CERTIFICATE OF APPROPRIATENESS PLACARD

412 KINSEY STREET

035-18-MW

Project Description:

412 Kinsey St - Exhibit A - Removal of utility chimney

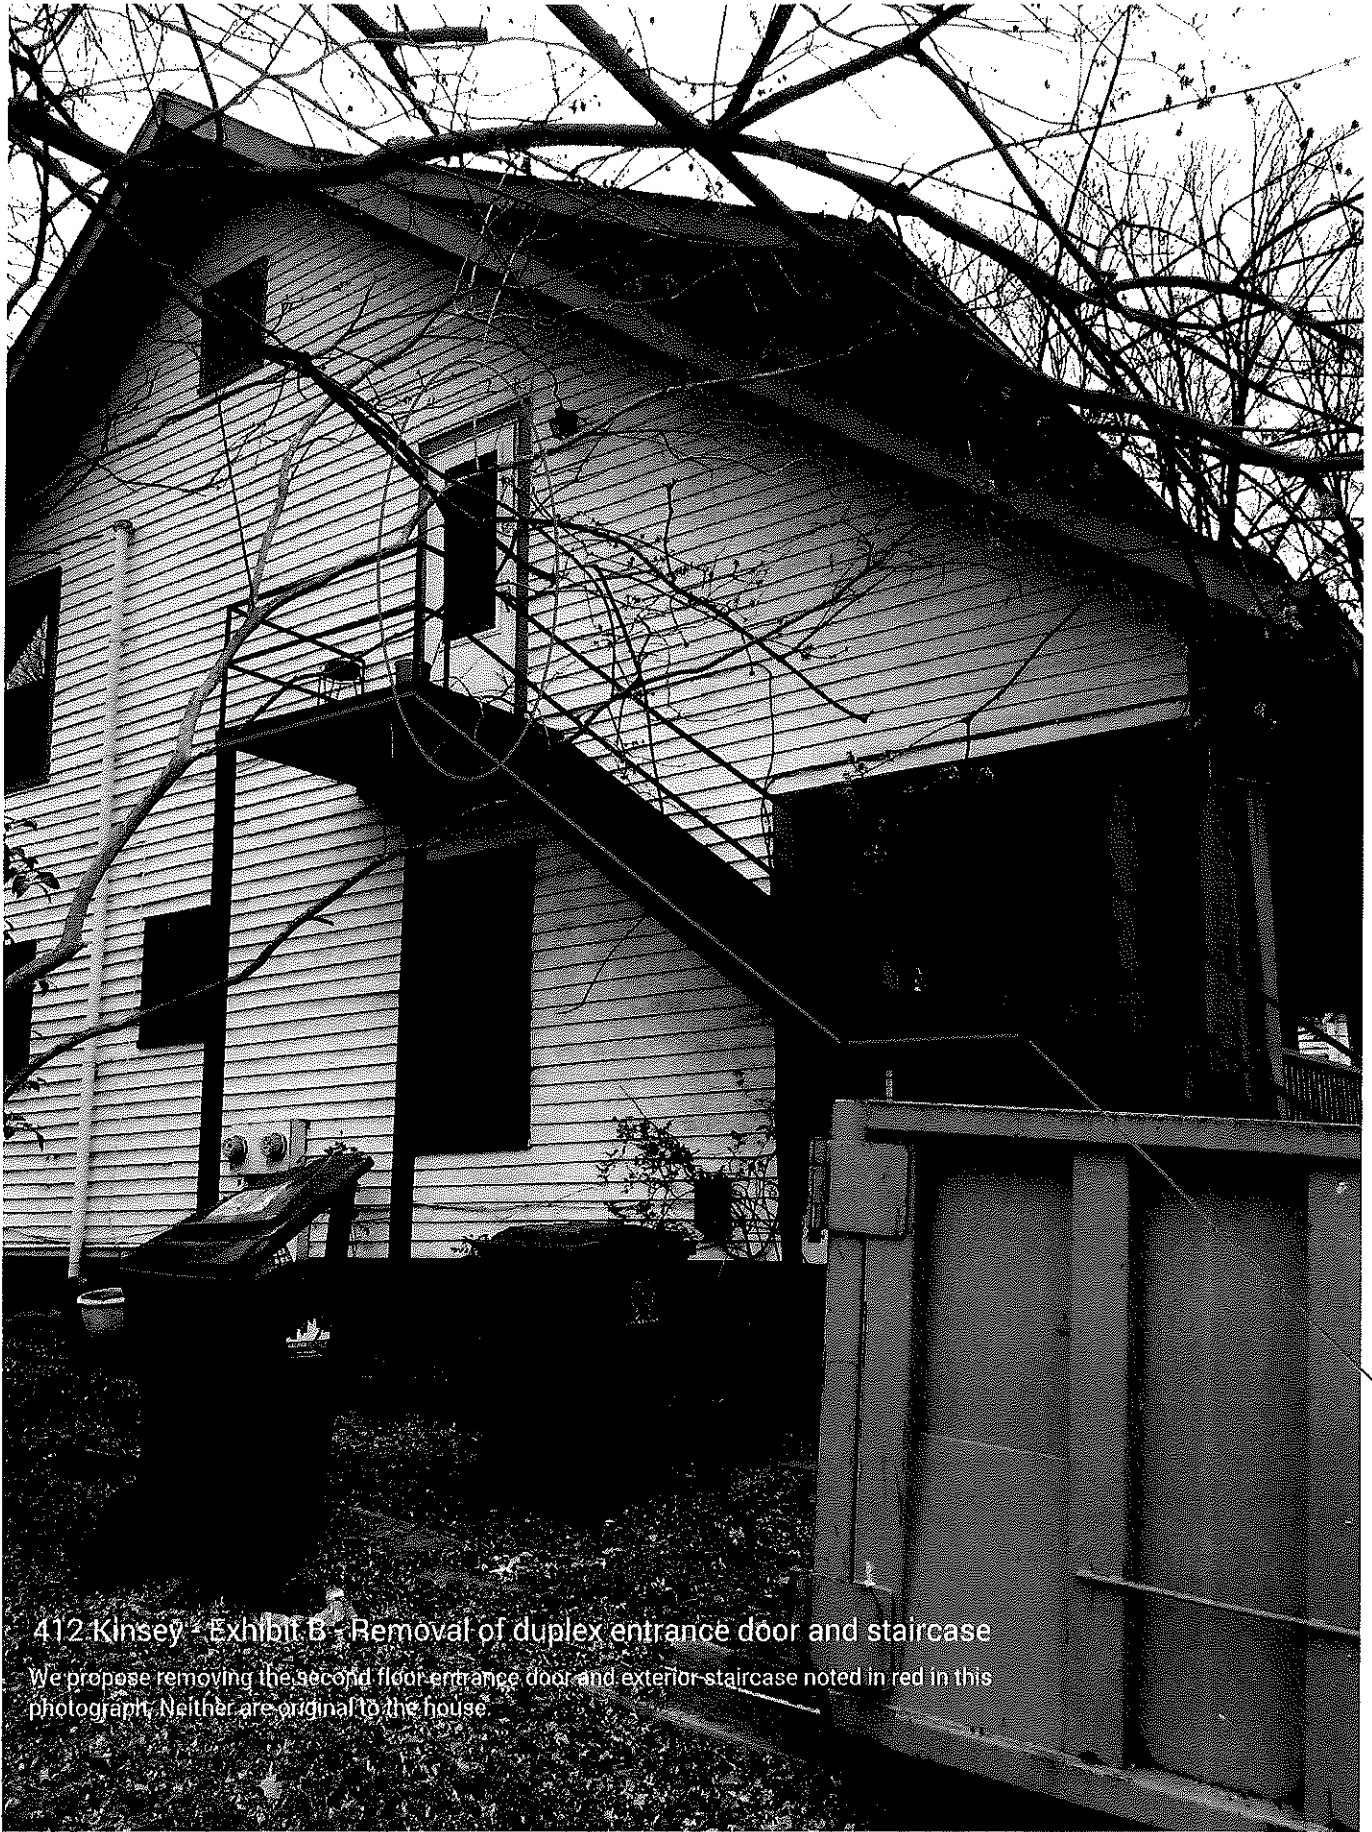
Also if you have any thoughts on the removal of the utility chimney and the fire escape that would be much appreciated.

Finally, as we come to a consensus on the windows, would it be possible to get approval to remove the utility chimney and the fire escape?

- Remove utility chimney and exterior fire stair

Side (South) Elevation - Existing	
Project number	17-015
Date	02/28/2018
Drawn by	LM
Checked by	N/A
A9-0	
Scale 3/16" = 1'-0"

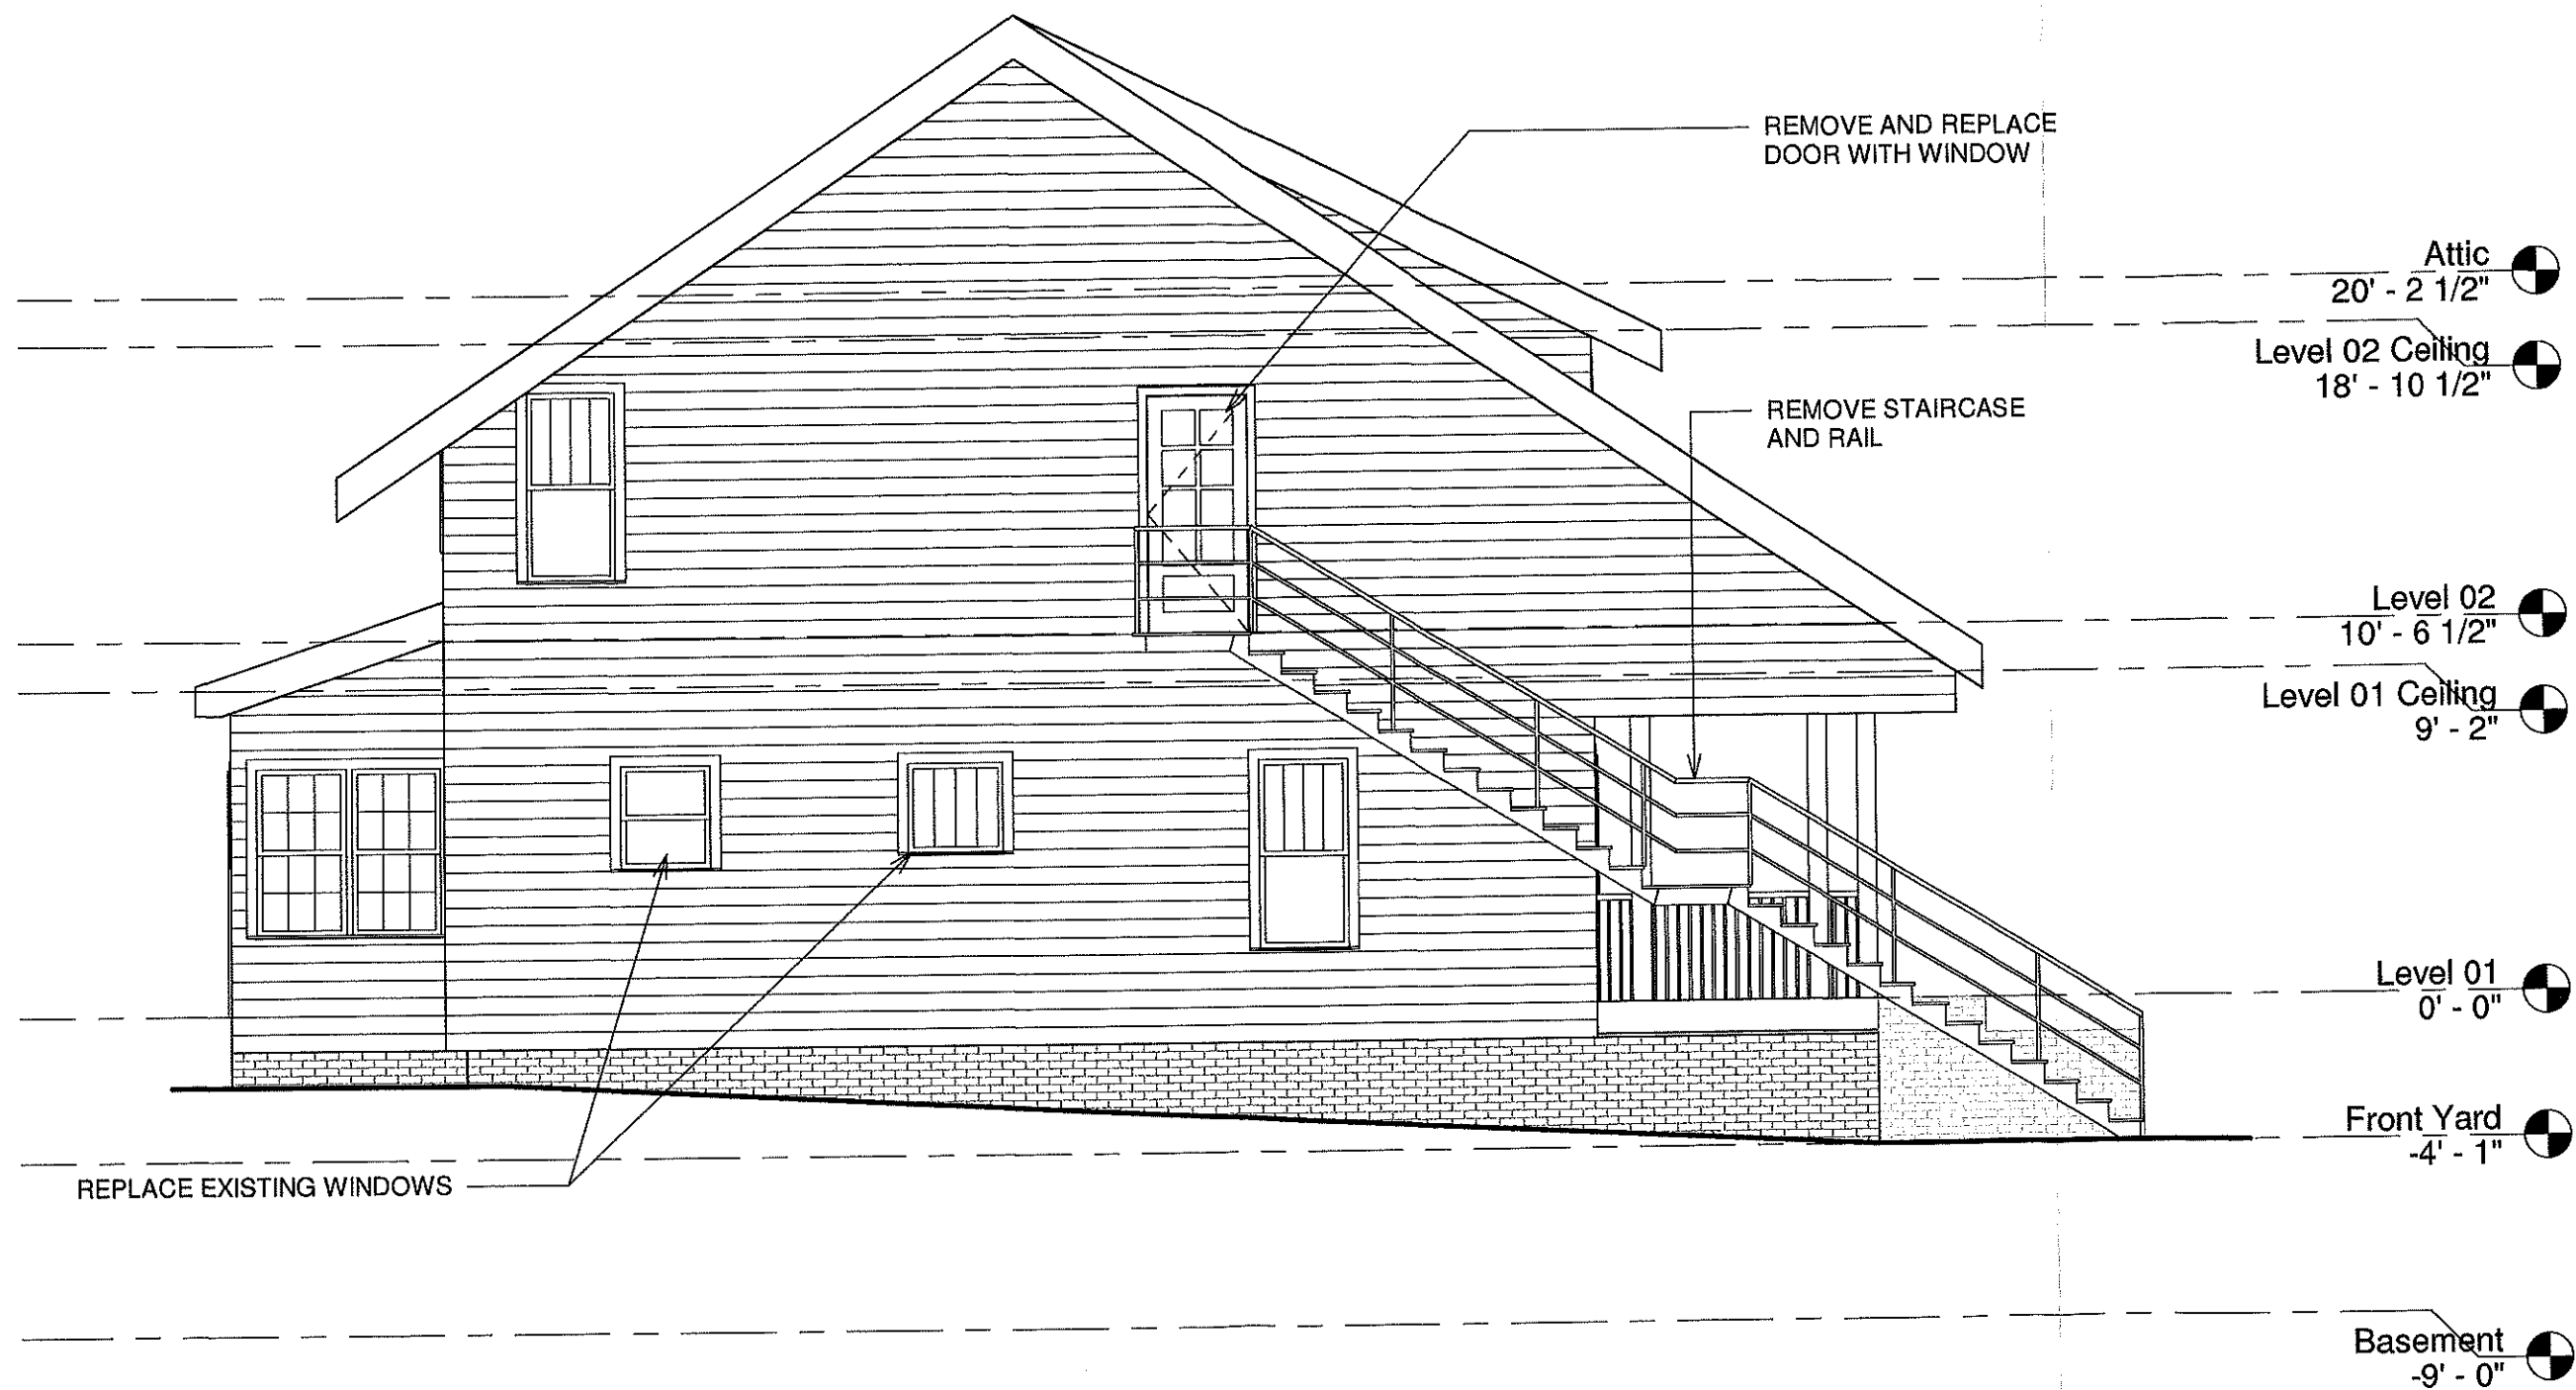
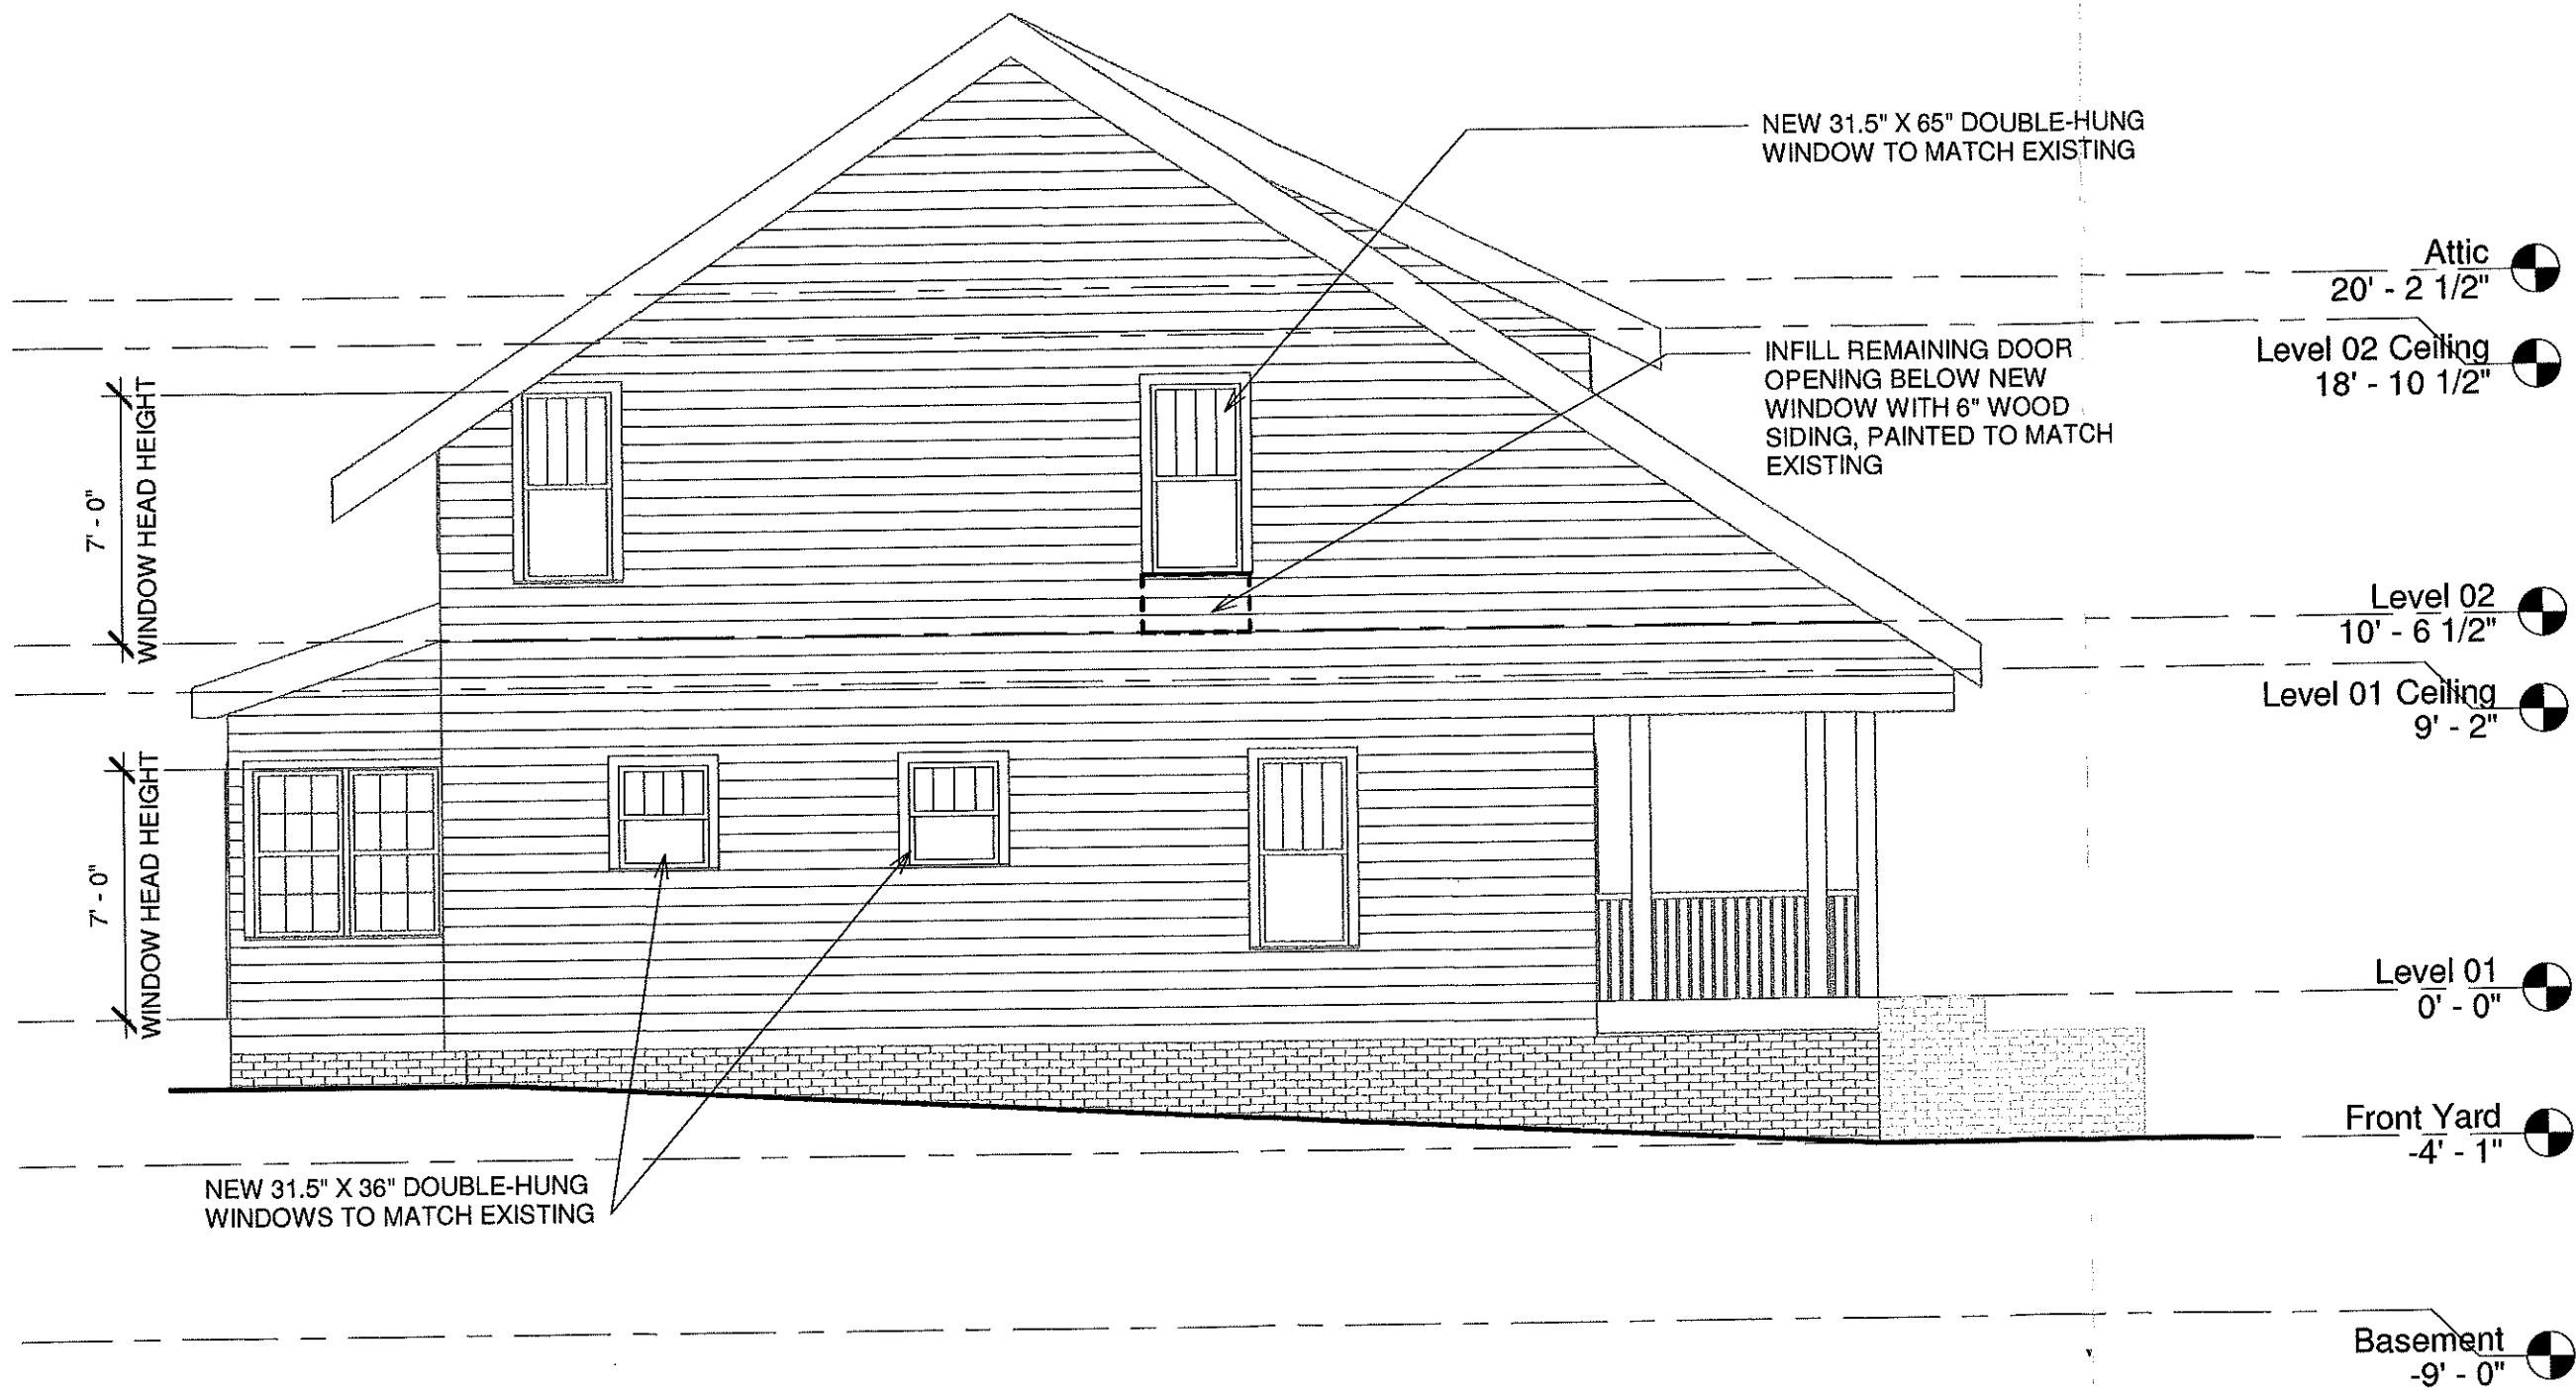
If you decide to continue pursuing wood windows, there is some concern about the design of the two proposed smaller windows. Guidelines 2.7.9 states, "Design such units to be compatible with the overall design of the building, but not to duplicate the original." A more historically appropriate proposal could utilize upper-sash style (the window with four vertical panes) casement windows OR double-hung one-over-one windows (similar to the existing window furthest to the rear).

We would like to proceed with separating the requests as you suggest. If you could proceed with reviewing the removal of the chimney and fire escape, I will prepare a separate application for the window replacement request. The intent right now is to provide a wood window specification. We will take your comments about the window design into account.
